CITY OF RICHMOND

DEPARTMENT OF PLANNING AND  
DEVELOPMENT REVIEW  
COMMISSION OF ARCHITECTURAL  
REVIEW

RE: 1903 E MARSHALL ST  
Application No. 12-015

## CERTIFICATE OF APPROPRIATENESS

Marshall Street View

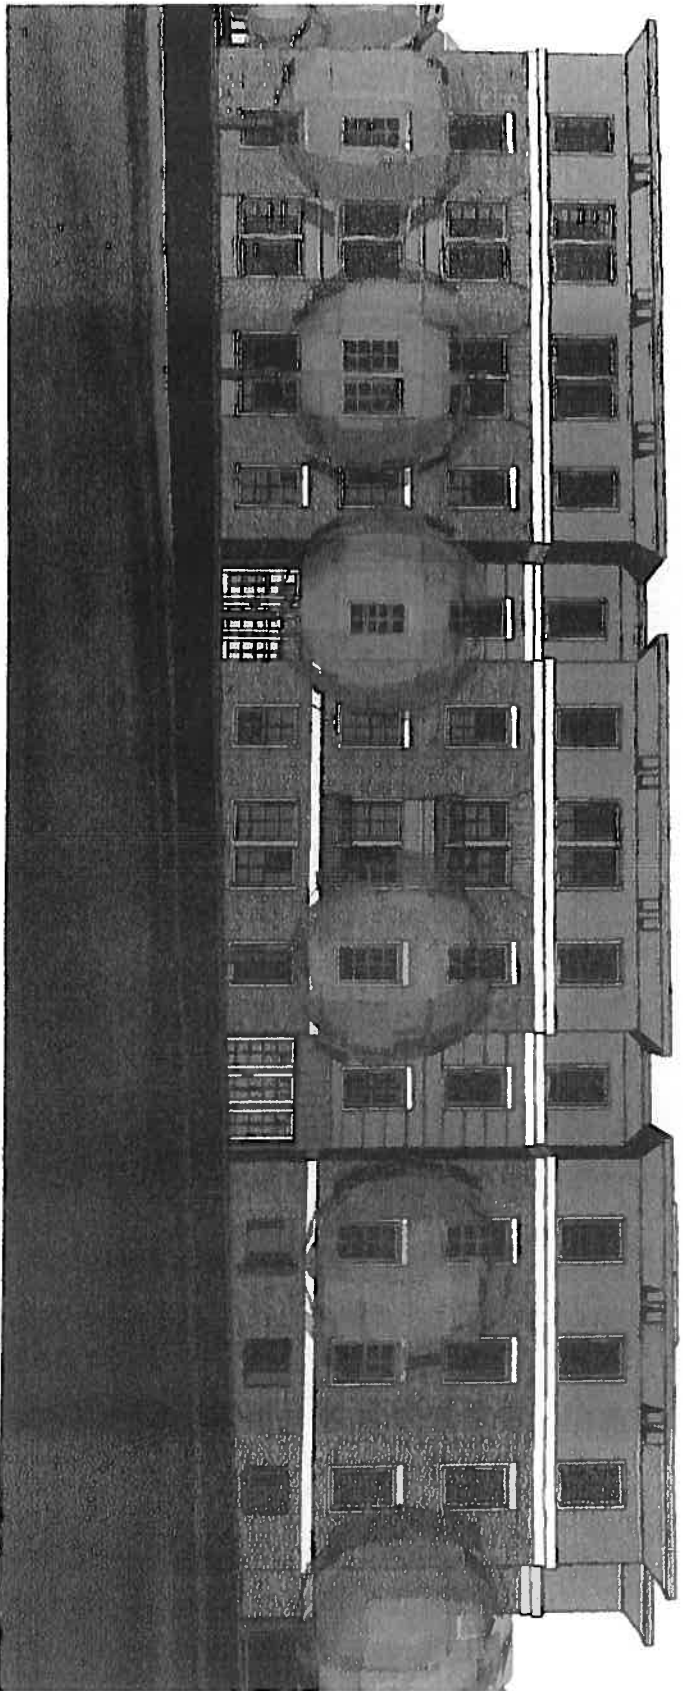
Ms. Easterling confirmed for Mr. Pearsall that she preferred to see the brick cladding extend up one entire bay instead of spanning the lower portion of several bays. She explained that it would be more effective at breaking up the massing of that elevation. She also noted her opposition to the proposed optional brackets at the cornice.

Mr. Green, Mr. Andrews, and Ms. Sadler expressed their opposition to the proposed cornice brackets.

- The cornice will not have any brackets
- The roof and mechanical unit screening will be gray in color unless otherwise approved by staff
- The stair tower on Marshall Street will include spandrel panels between the windows
- The Juliet balconies be coordinated with the window/door openings
- The bottom of the Juliet balconies will be level with the interior floor

Alternate No. 2 – Add brick at 4<sup>th</sup> floor at 20<sup>th</sup> Street and Marshall Corner in addition to cornice brackets (Alt No. 1).

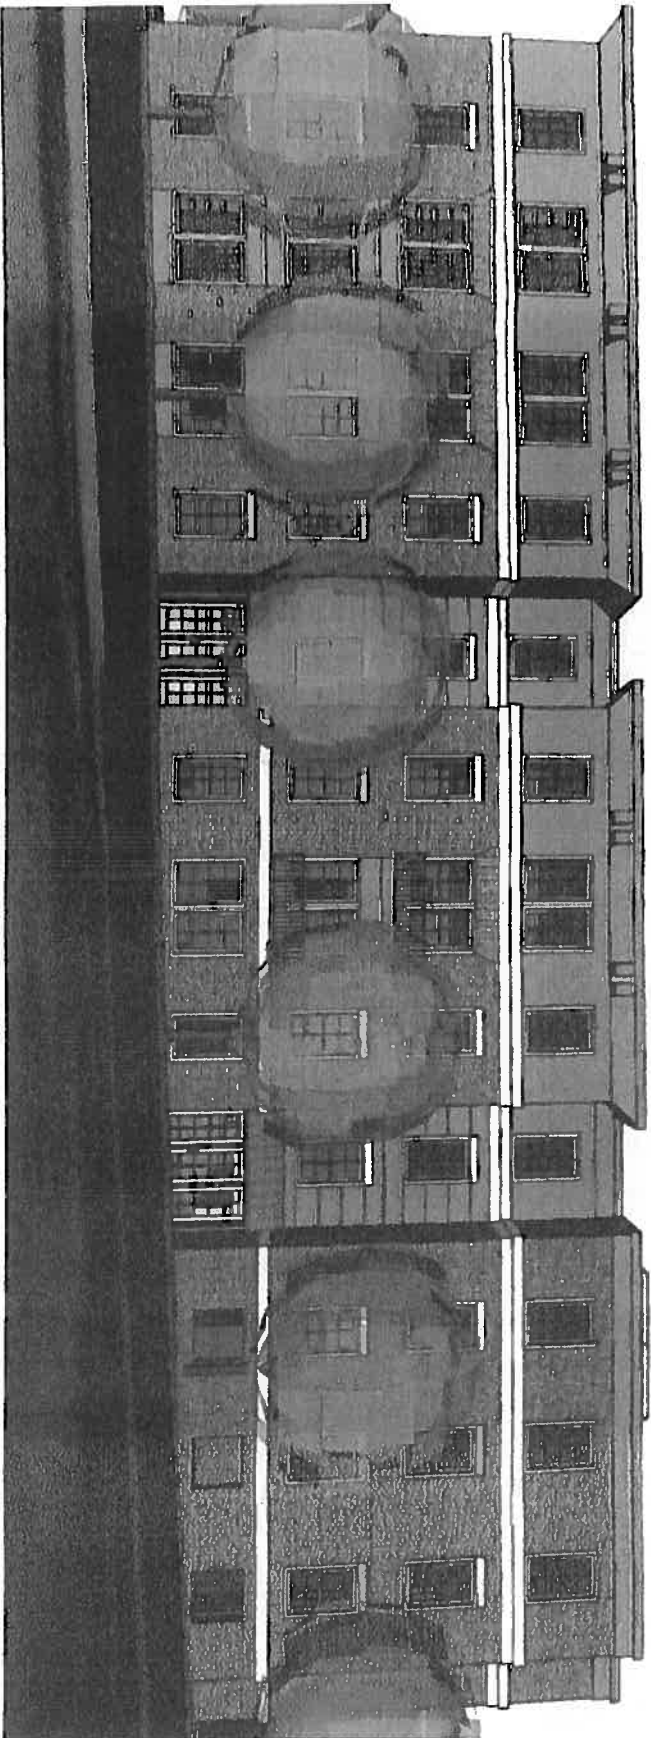
Mr. Elmes stated that he supports Mr. Green's suggested revisions to the brick on the south elevation. He noted his preference for the second alternative that depicts different cornices for the 20<sup>th</sup> and Marshall Street corner.

WHEREAS, the brick cladding at the corner of 20<sup>th</sup> and Marshall will extend up to include the fourth floor, and

# SOUTH ELEVATION

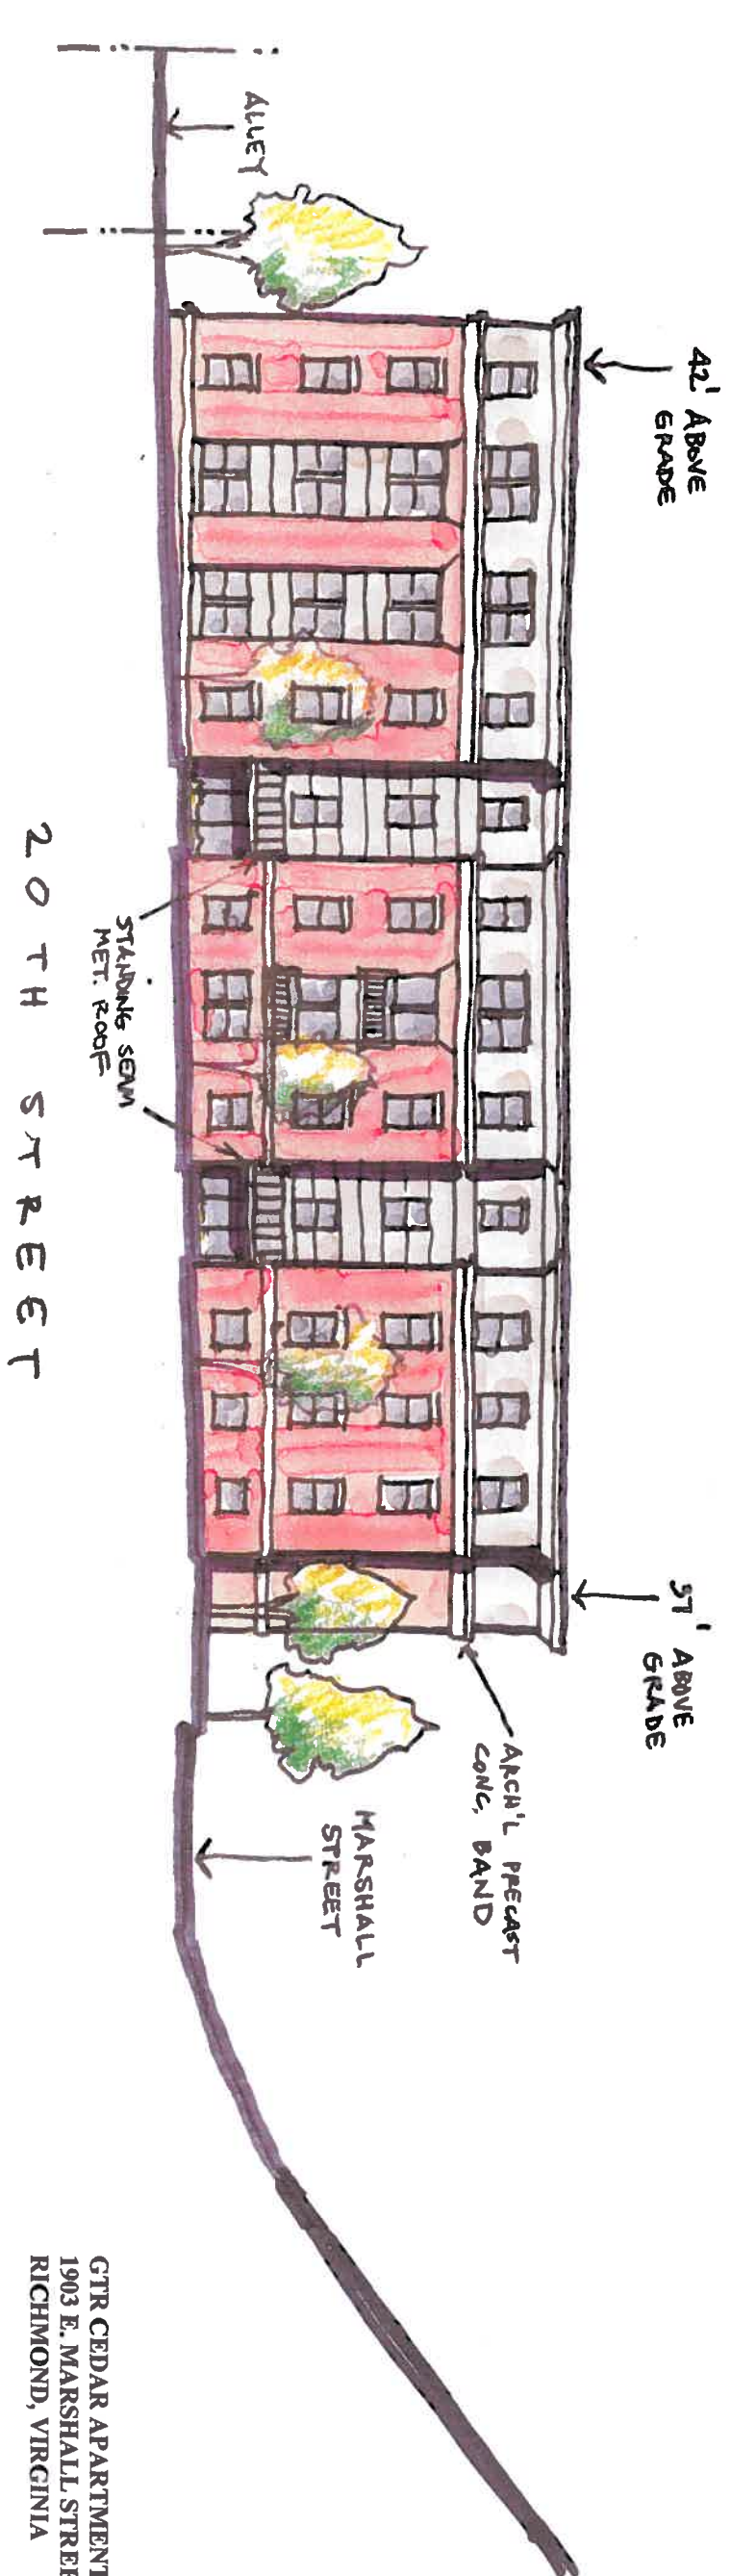
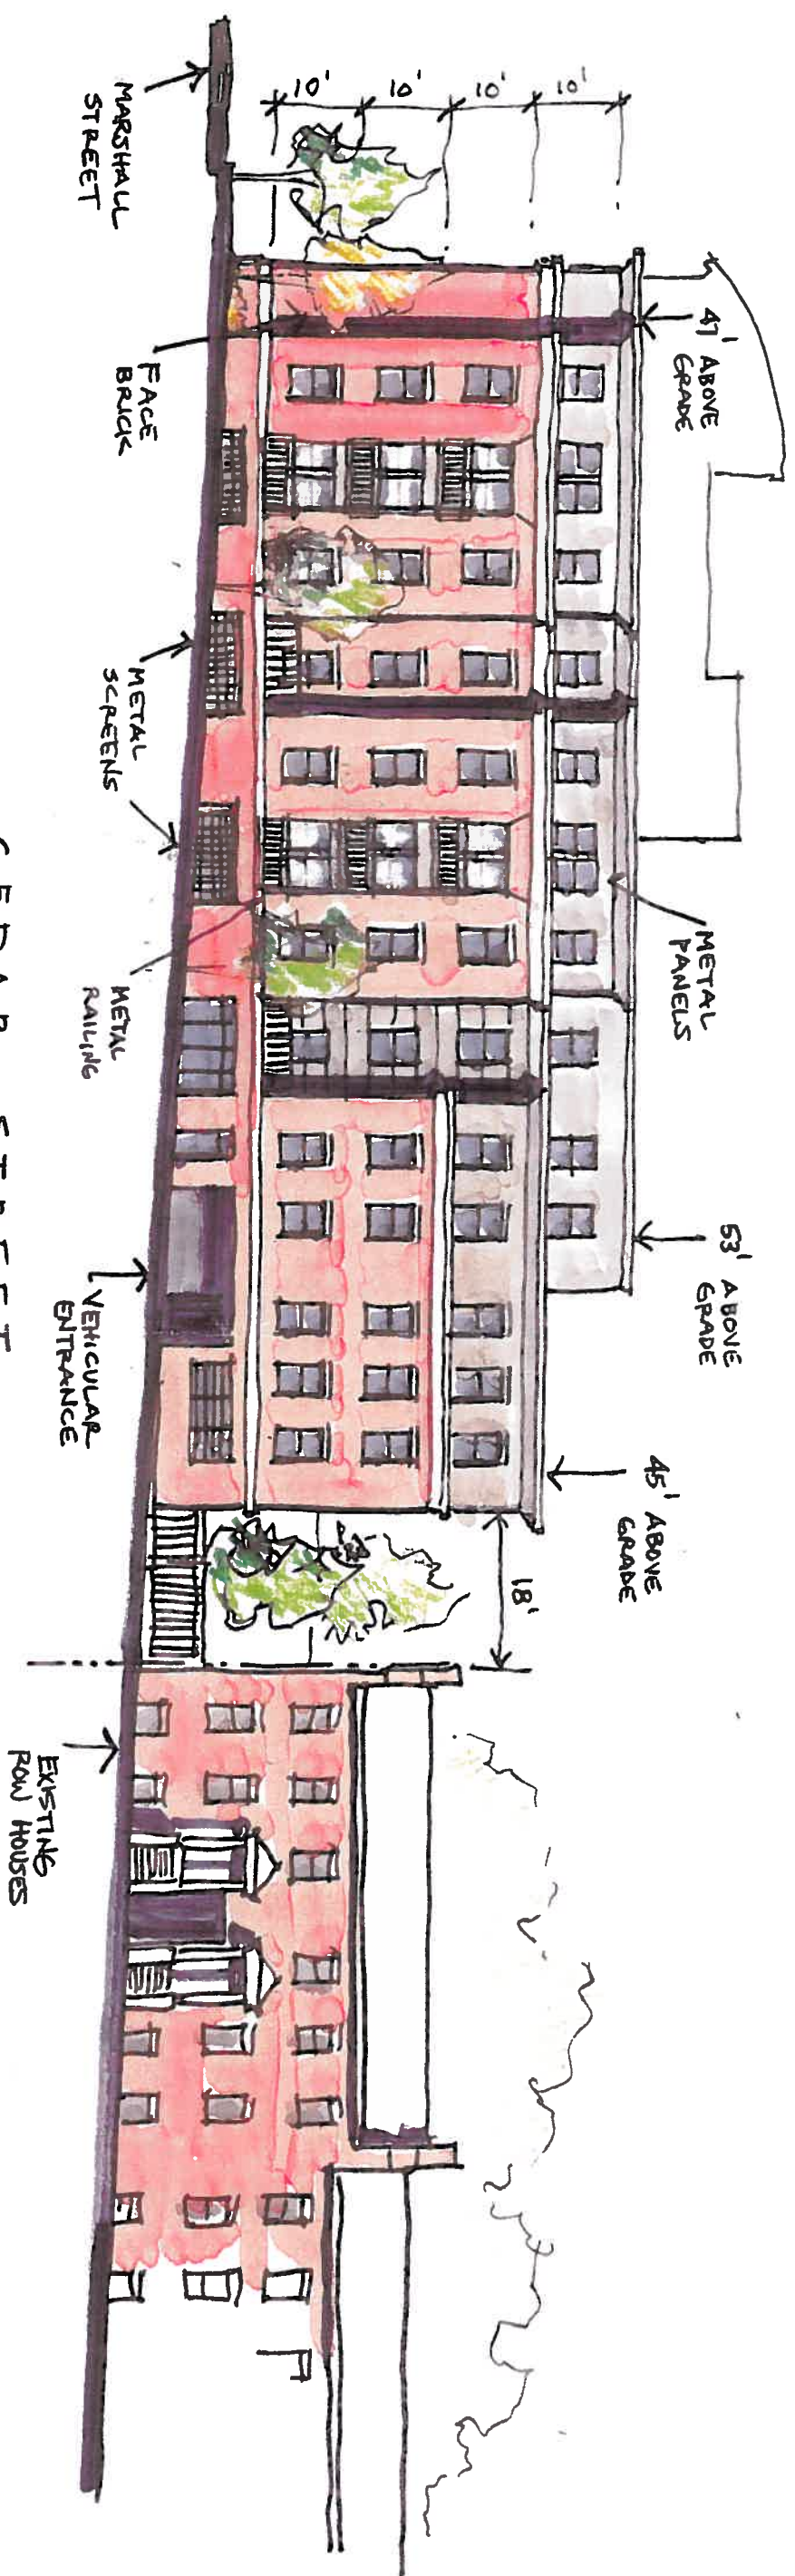
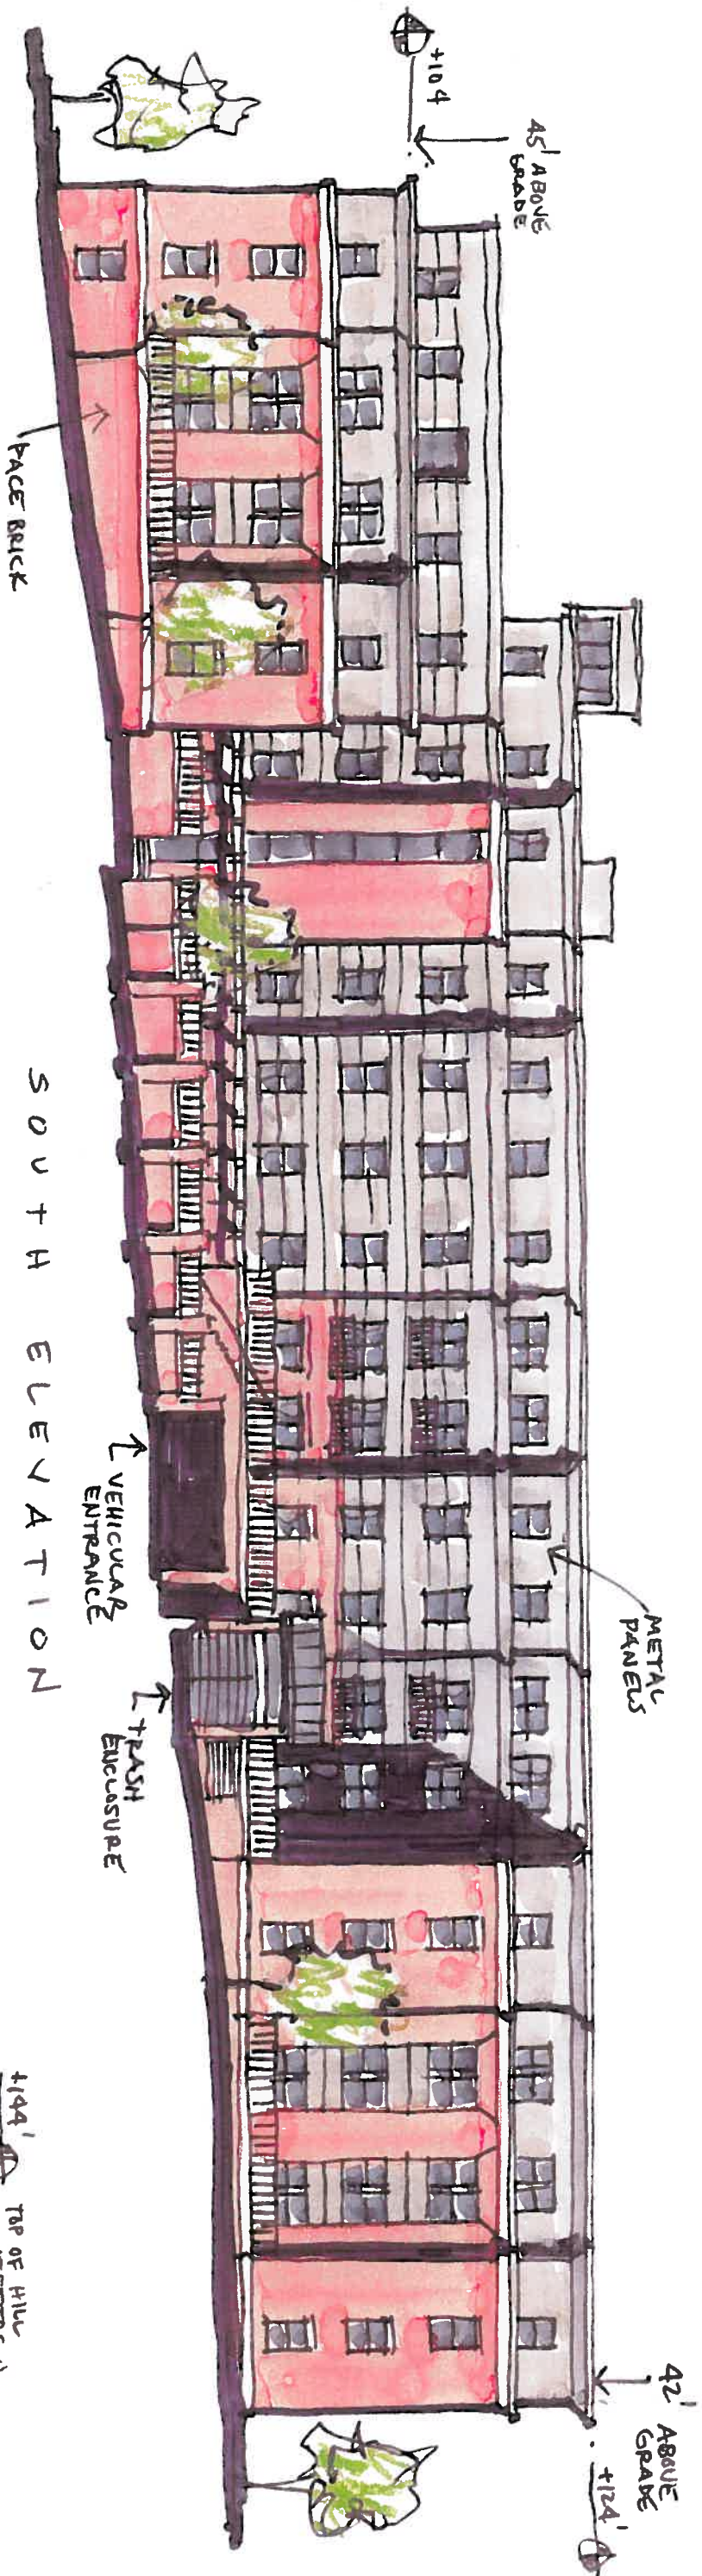
Mr. Pearsall inquired about the use of brick cladding on the south elevation. Mr. Craig noted that they would be willing to carry the brick up one entire bay, if the Commission required it.

Mr. Green suggested bringing the brick cladding all the way up on two bays of the south elevation. He noted that the current placement of the brick was not effective.

Green – Design would be stronger if the massing came down to the ground, more brick on south elevation.

WHEREAS, the brick cladding along the alley elevation shall be carried up two bays to the bottom of the fourth floor, and
